Access Compliance Report

Public Rights-of-Way

(Curb Ramps)

Intersection ID: N/A	Main Street: N_COMMUNITY_HOUSE_RD	Cross Street: ENDAHVEN_LN	Location: SE
ADA ID: 47FE1691DB21	Ramp Type: Perp	Initial Pass/Fail: Fail	Overall Compliance: No
Codes/Mitigation Info/Possible Solution		Field Measurements/Component Compliance	
Severity Score: 13.75

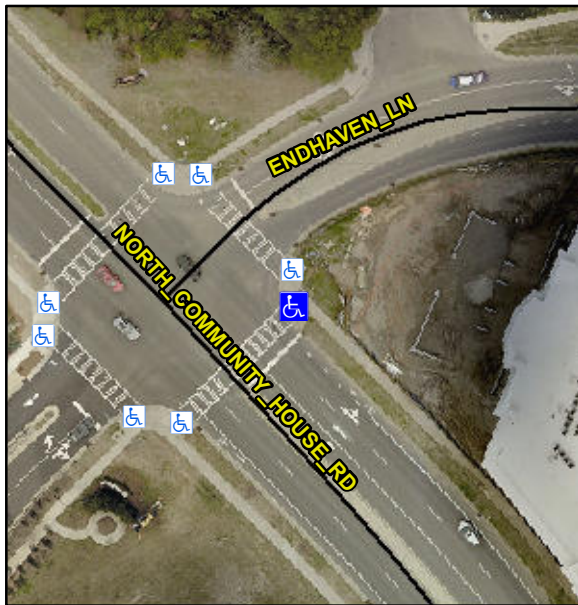
R304.2.2, R304.5.3

Compliance	Description	Data	Compliance	Description	Data
N/A	Ramp Length (in)	88.0	No	Ramp Slope (%)	9.1
Yes	Ramp Width (in)	48.5	No	Ramp XSlope (%)	4.3
N/A	Flare Type LT	N/A	N/A	Flare Type RT	N/A
N/A	Flare Slope LT (%)	N/A	N/A	Flare Slope RT (%)	N/A
N/A	Flare Traversable LT?	N/A	N/A	Flare Traversable RT?	N/A
N/A	Landing Length (in)	N/A	N/A	DWS Provided?	N/A
N/A	Landing Width (in)	N/A	N/A	DWS Contrast?	N/A
N/A	Landing Slope (%)	N/A	N/A	DWS Length (in)	N/A
N/A	Landing X Slope (%)	N/A	N/A	DWS Full Width?	N/A
N/A	Landing Curb? (Y/N)	N/A	N/A	DWS Offset (in)	N/A
N/A	Shared Landing?	N/A			
N/A	Gutter Ponding?	N/A	N/A	Gutter Slope (%)	N/A
N/A	Gutter Lip Ht (in)	N/A	N/A	Gutter X Slope (%)	N/A
N/A	Painted X Walk1?	Yes	N/A	Painted X Walk2?	N/A
	X Walk 1 Direction	To SW		X Walk 2 Direction	N/A
N/A	X Walk 1 Width (in)	114.0	N/A	X Walk 2 Width (in)	N/A
	X Walk 1 Slope (%)	0.8		X Walk 2 Slope (%)	N/A
	X Walk 1 X Slope (%)	1.3		X Walk 2 X Slope (%)	N/A

Remove & Replace Entire Ramp.
